Request for Class II Permissive Change

FCC ID: VG8XM048KYY

Please be notified that we, the undersigned, **Guangdong Midea Kitchen Appliances Manufacturing Co.,Ltd.** declare that the reasons for this class II permissive change are as below:

Original Mother board-top view

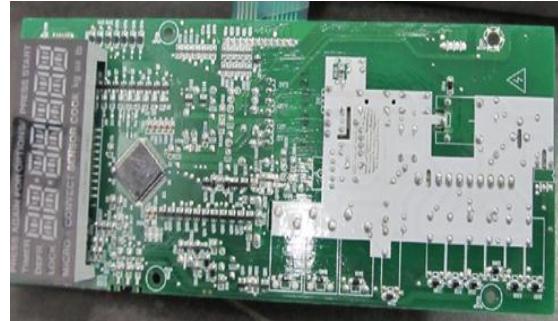
1. Changed mother board as below.

- a) With the same input&output power and similar circuit function.
- b) Changed Linear transformer to switching power supply(see 2).

a) Only differences for component and PCB Layout.
